Issue	**1**
Factory ID	**26207**
Date of Issue	**04-Jun-2026**

Arshad Corporation (Pvt.) Ltd. (Apparel Division)

Structural Safety Inspection Report

Pakistan Accord Initial Safety Inspection Report

Figure 2.3 - Missing edge protection location at roof of Main Building

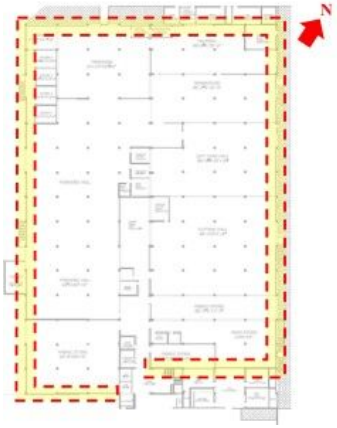
This refers to the Main Building.
Edge protection is not provided on the roof level of Main Building. Missing edge protection presents a risk of potential injury resulting from slip, trip or fall from the roof, while accessing and maintaining services on the roof. This is a Health and Safety Concern. F-202604-066153

Timeline	Remediation Plan
Immediate CAP-0078926	Provide adequate edge protection on the roof, and on any other part of the factory with the same issue.
